Request for Continued Examination (RCE) Transmittal

Application Number	10/798,693
Filing Date	03/11/2004
First Named Inventor	Stanton
Art Unit	3673
Examiner Name	LEE
Attorney Docket Number	CLPS-18789

RESPONSE TO OFFICE ACTION DATED JUNE 10, 2009

Amendments to the Drawings: Replacement Sheets for Figures 4, 6, and 12.

FIG. 4

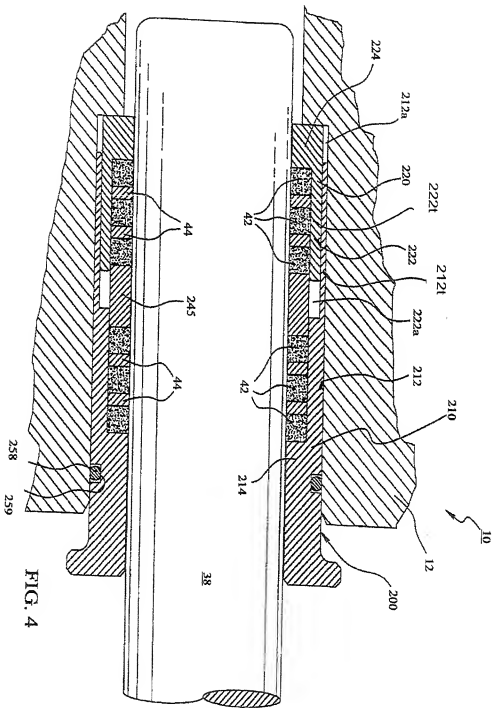
The drawings were objected to under 37 CFR 1.83(a) because the specific terms “telescoping structures” as used in the currently- pending claims were not identified in the drawings. Applicants amend as required by the Examiner.

Regarding Figure 4, Paragraphs 0145 and 0146 of the specification are amended to include the specific references 212t and 222t for the “telescoping structures” and Figure 4 of the drawing is amended to include these references. Further support for these amendments is found in the specification, for example, in Paragraph 0145:

[0145] As will be appreciated, the telescoping structures 212t and 222t of the first sleeve portion **212** and the second sleeve portion **222** allow for squeezing of the first abutment ring **214** and the second abutment ring **224** co-axially closer to one another after positioning the pre-assembled packing cartridge **200** on a plunger **38** in the packing bore **28**. This axial squeezing is initially provided by the gland nut **32** (not shown in **Figure 4**). The gland nut initially can be tightened to the specifications of the packing elements **42**. In addition, from time to time, the gland nut can be tightened further to further squeeze the packing elements **42** in compensation for wear during operation of the pump. Preferably, these telescoping structures 212t and 222t allow for at least sufficient overlapping travel in areas **212a** and **222a** to allow for the expected crushing of packing during the operation of a plunger **38** though the packing cartridge **200**. For example, the expected crush of the packing rings may be about 0.4 inches.

[0146] Preferably, a spacer ring **245** is positioned operatively to cover the overlapping travel of inwardly exposed area **222a** of the telescoping structures 212t and 222t between the first and second sleeve portions **210** and **220**. This spacer ring **245** helps prevent seepage of fluid into any clearances between the first sleeve portion **210** and the second sleeve portion **220**. The spacer ring **245** can also act as a back-up ring for the packing rings **42**.

FIG. 6

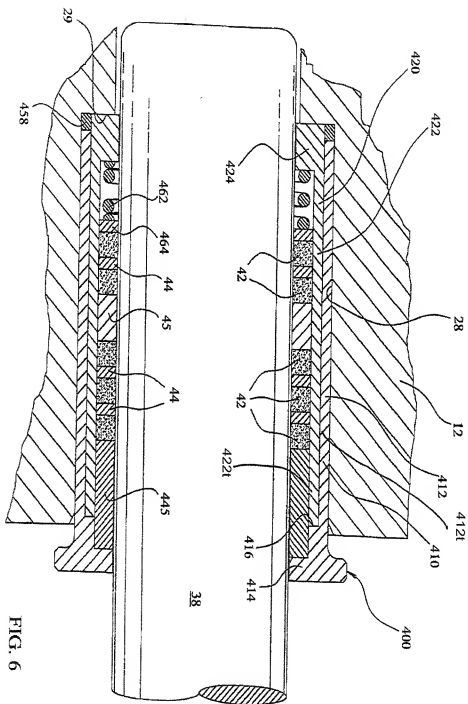
Regarding Figures 6 and 12, Paragraphs 0156 and 0158 of the specification are amended to include the specific references 412t and 422t for the “telescoping structures” and Figures 6 and 12 of the drawing is amended to include these references. Figure 12 is a cross-sectional view of another embodiment of a packing cartridge similar to the embodiment shown in Figure 7 (*See, e.g.,* Specification Paragraphs 0076 and 0193), where Figure 7 is a cross-sectional view of another embodiment of a packing cartridge similar to the embodiment shown in Figure 6 (*See, e.g.,* Specification Paragraphs 0068 and

[0156] Preferably, a spacer ring **445** is positioned operatively to cover the overlapping travel of the telescoping structures 422t and 412t between the first and second sleeve portions **410** and **420**. This spacer ring **445** helps prevent seepage of fluid into any clearances between the first sleeve portion **410** and the second sleeve portion **420**. The spacer ring **445** can also act as a back-up ring for the packing rings **42**.

[0158] As will be appreciated, the telescoping structures 422t and 412t of the first sleeve portion **412** and the second sleeve portion **422** allow for squeezing of the first abutment ring **414** and the second abutment ring **424** co-axially closer to one another after positioning the pre-assembled packing cartridge **400** on a plunger **38** in the packing bore **28**. However, in this embodiment, the packing cartridge **400** is positioned in the packing bore **28** and tightened by a gland nut (not shown) until the second sleeve portion **422** bottoms out against a shoulder **416** of the first sleeve portion **412**. In this position, the coil spring **462** is compressed with a packing assembly positioned between the first abutment ring **414** and a second abutment ring **424**. The advantage of bottoming out the telescoping structures 422t and 412t is that it prevents over-tightening of the packing cartridge **400** in the packing bore **28**. The spring **462** maintains a pre-determined amount of axial compression on the packing rings **42** of the packing stack.
